Access Report – Concept Design NCC/BCA 2022 – Volume 1, Amendment 2

Garden Suburb

Lot 67 & Lot 68 Myall Road, Hillsborough NSW 2289

Prepared for: Landcom
Our Ref: 25000313 | Issue date: 17 October 2025

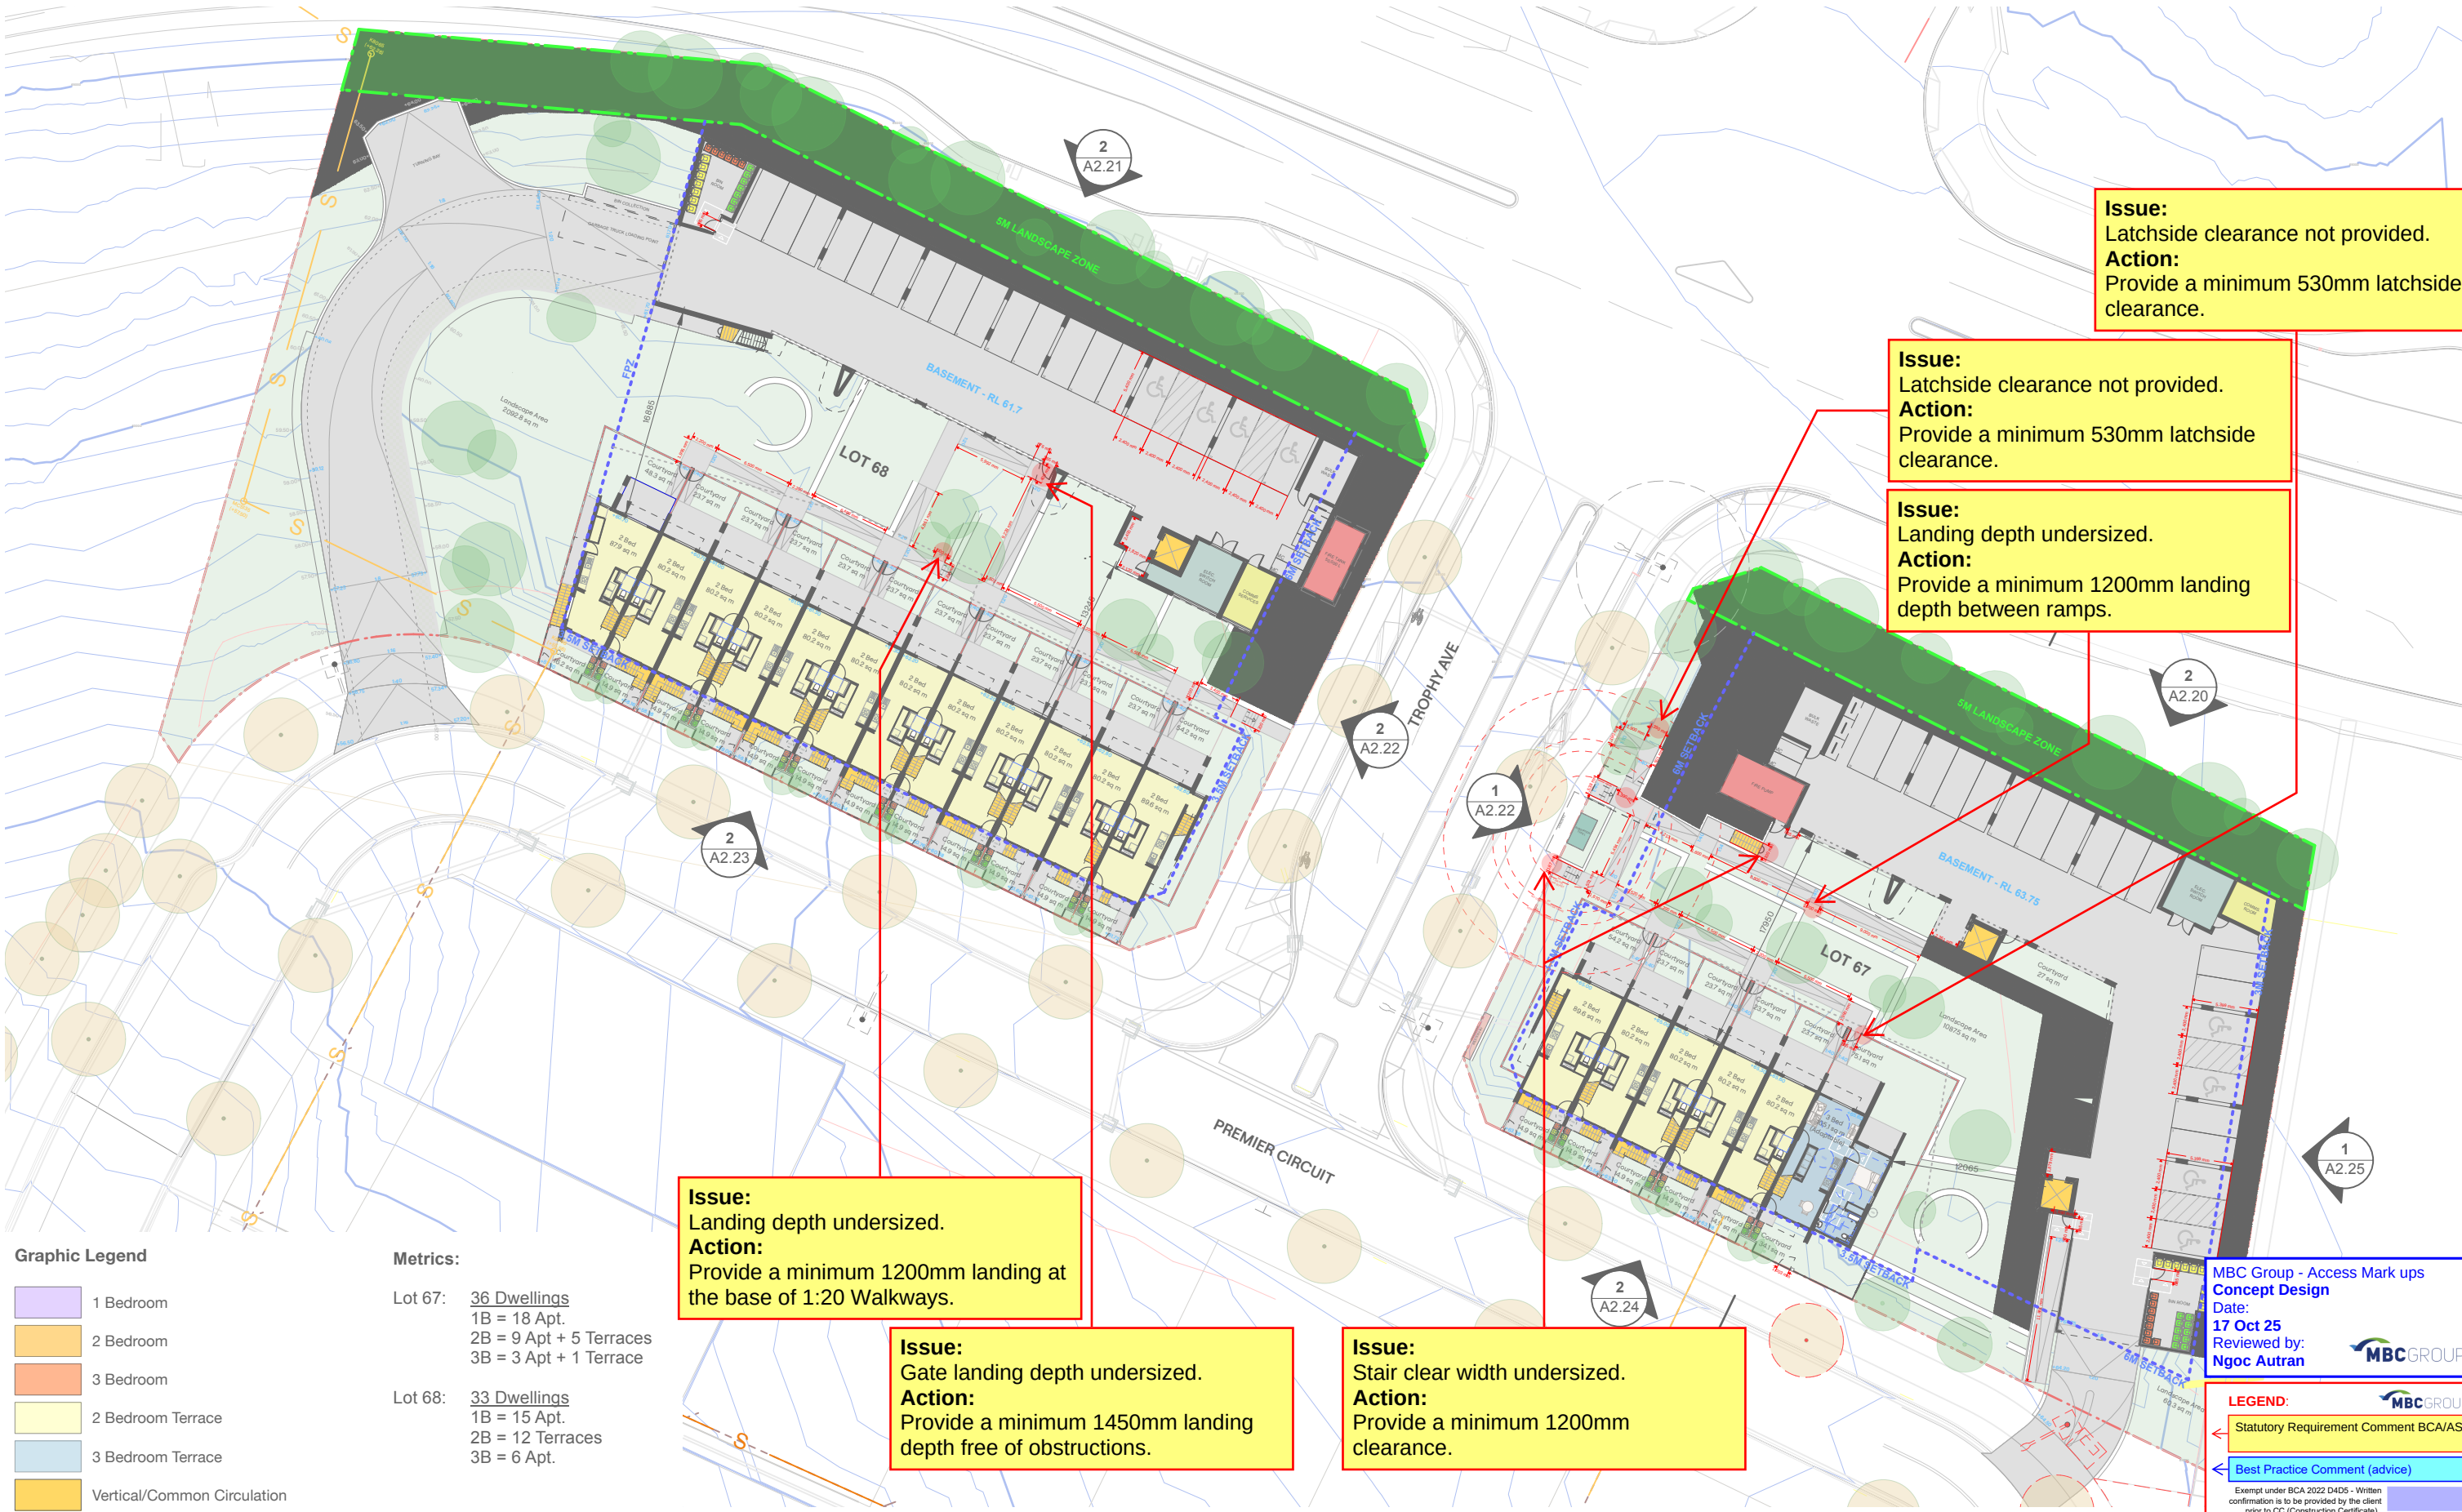
Issue:
Landing depth undersized.
Action:
Provide a minimum 1200mm landing at the base of 1:20 Walkways.

Issue:
Gate landing depth undersized.
Action:
Provide a minimum 1450mm landing depth free of obstructions.

Issue:
Stair clear width undersized.
Action:
Provide a minimum 1200mm clearance.

Issue:
Latching clearance not provided.
Action:
Provide a minimum 530mm latching clearance.

Issue:
Landing depth undersized.
Action:
Provide a minimum 1200mm landing depth between ramps.

Issue:
Latching clearance not provided.
Action:
Provide a minimum 530mm latching clearance.
